## Solicitation Amendment No. 001

<b>To:</b>	<b>Date:</b>
Prospective Proposers:	September 17, 2012
<b>Project Title:</b>	<b>Project No.:</b>
Roofing Services – 3100 Main Street	12-08

**ADDENDUM NO. 1 FOR  
HOUSTON COMMUNITY COLLEGE SYSTEM  
3100 MAIN ROOFING PROJECT  
PROJECT NO. 12-08**

**ADDENDUM NO. 1 FOR  
HOUSTON COMMUNITY COLLEGE SYSTEM  
3100 MAIN ROOFING PROJECT, HOUSTON, TX  
PROJECT NO. 12-08  
SEPTEMBER 14, 2012  
PAGE 2 OF 2**

SDA1.01  
OF  
1

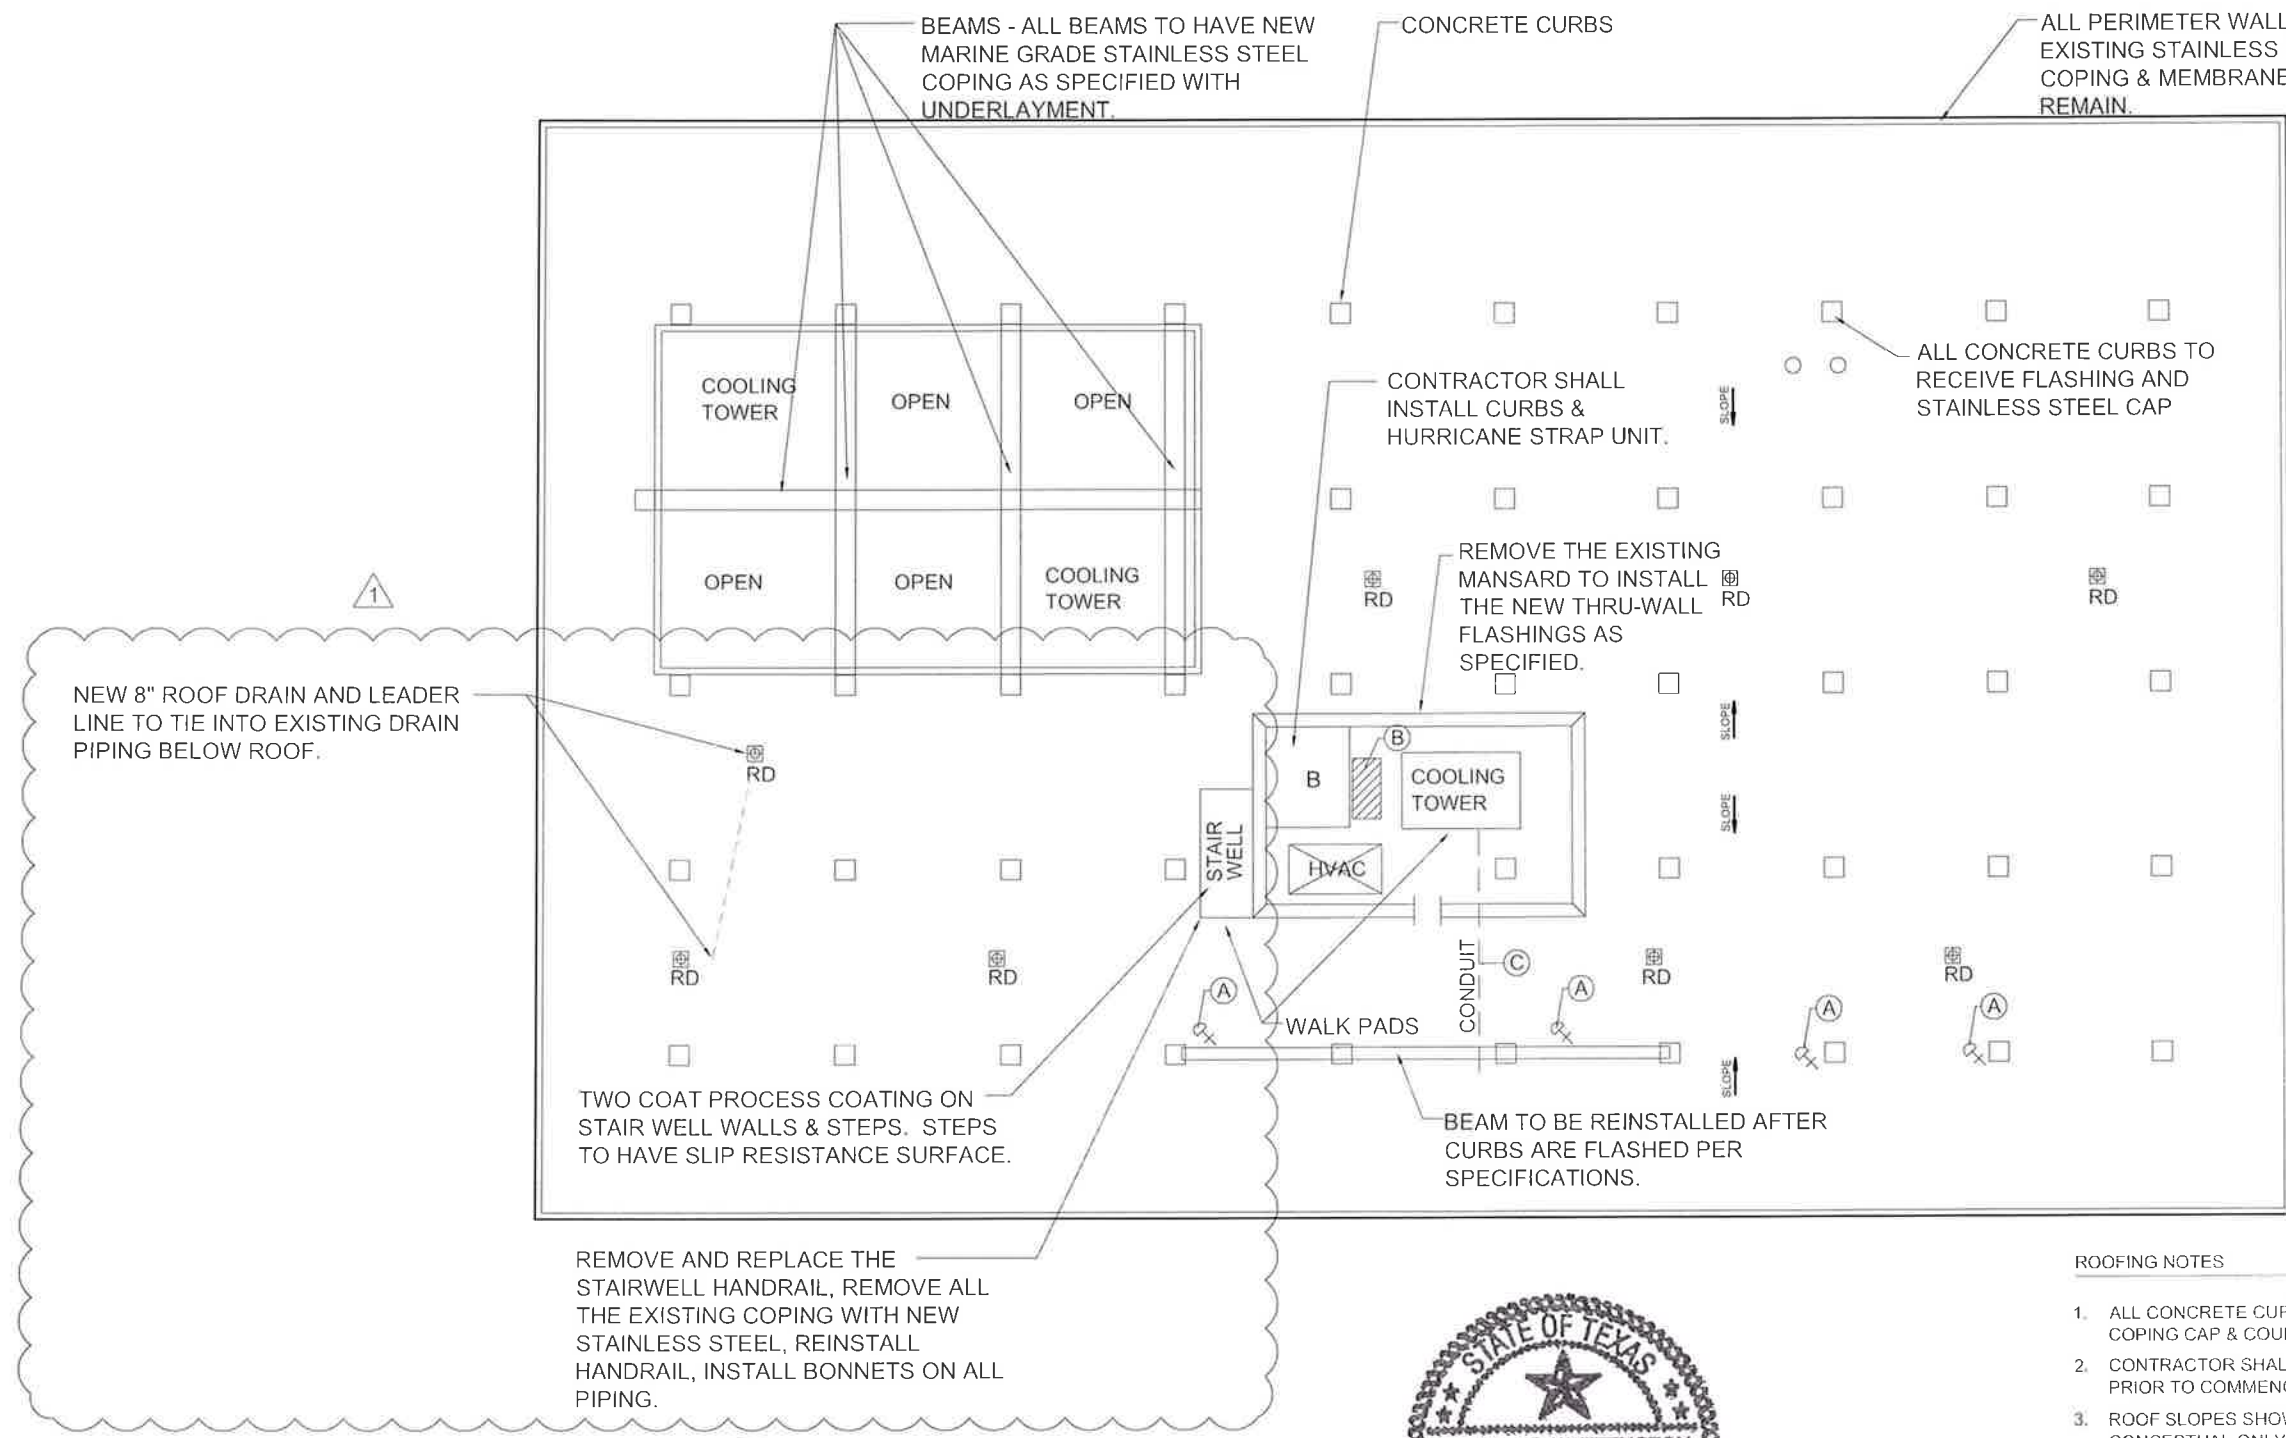
**Roof Plan A1.01:**

7. Shows an existing roof drain just south of the Cooling Tower Well Area. There is no drain at that location. Please clarify.

8. **Note 6.** States contractor to install one-fourth inch (1/4") per foot slope tapered insulation while specification Section 07535, Page 55, Paragraph 2.08B and Attachment No. 3 both call for one-eighth inch (1/8") per foot slope. Please clarify.

11. Revised Roof Plan No. SDA 1.01, dated 09/14/12 is attached, which shall be made part of the plans and specifications for this project.

**Answer: Contractor is to install one additional eight inch (8") drain bowl and associated assembly items in the location as indicated on the roof plan that indicates the areas of the existing drain. Drain installation shall include cast iron pipe leader line elbows, strapping to the deck system to tie into the existing drain lines to the south. All connections and piping and drain assembly items are to be included in the base proposal price.**

**Answer: All taper insulation is to be one-eighth inch (1/8") per foot taper.**

- ROOFING NOTES**
1. ALL CONCRETE CURBS TO RECEIVE STAINLESS STEEL COPING CAP & COUNTERFLASHING.
  2. CONTRACTOR SHALL FIELD VERIFY ALL EXISTING CONDITIONS PRIOR TO COMMENCING WORK.
  3. ROOF SLOPES SHOWN ON DRAWING ARE GENERAL AND CONCEPTUAL ONLY. PROVIDE POSITIVE DRAINAGE TO ALL ROOF DRAINS. VERIFY IN SHOP DRAWINGS.
  4. PROVIDE TAPERED INSULATION CRICKETS (1/8" FT. MIN. SLOPE) AT HIGH SIDE OF ALL MECHANICAL UNITS SMOKE VENTS, ROOF HATCHES & OTHER MISC. ROOF PENETRATIONS, TO SHED WATER AROUND & TO ENSURE POSITIVE ROOF DRAINAGE.
  5. RECERTIFY LIGHTNING PROTECTION.
  6. CONTRACTOR TO INSTALL 1/8" PER FOOT SLOPE TAPER INSULATION AS SPEC.

PROJECT FOR: HOUSTON COMMUNITY COLLEGE SYSTEM 3100 MAIN BLDG. HOUSTON, TX		SDA2.01 OF 1
DETAIL NAME: ROOF TIE IN		
PROJECT NO: 20120817-41		ADDENDUM NO. 1
SCALE : NOT TO SCALE	DATE: 09/14/12	DRAWN BY: ST

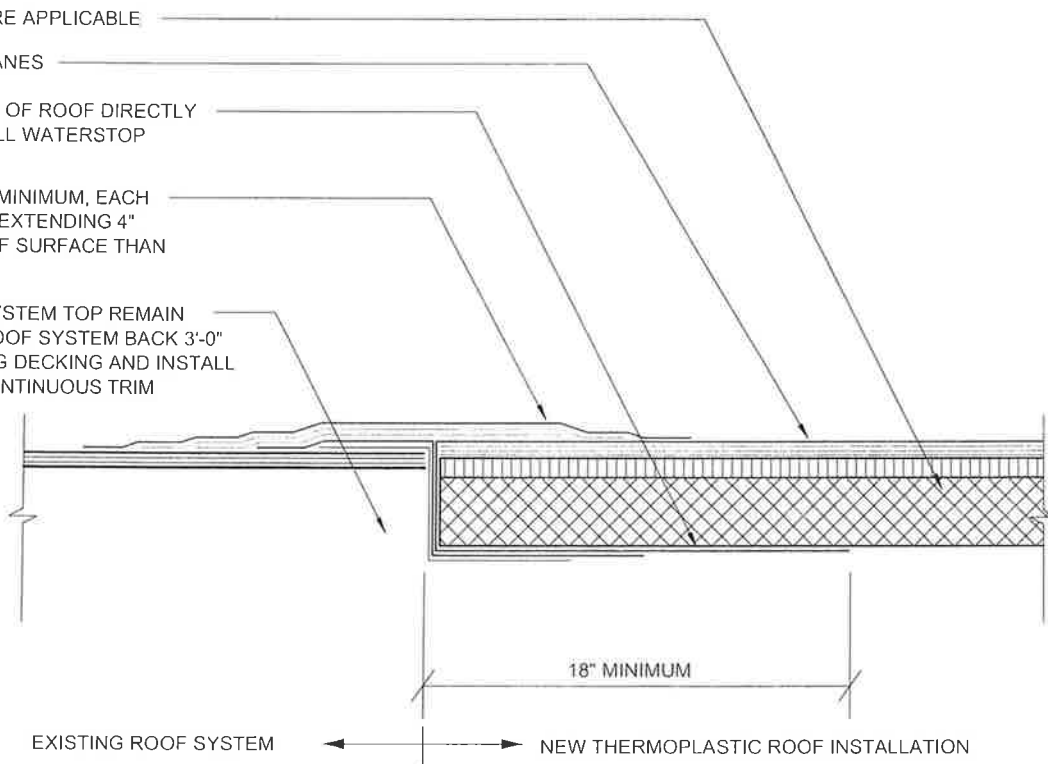
12. New Detail No. SDA2.01, dated 09/14/12 is attached, which shall be made part of the plans and specifications for this project.

1 ADD THIS DETAIL IN IT'S ENTIRETY
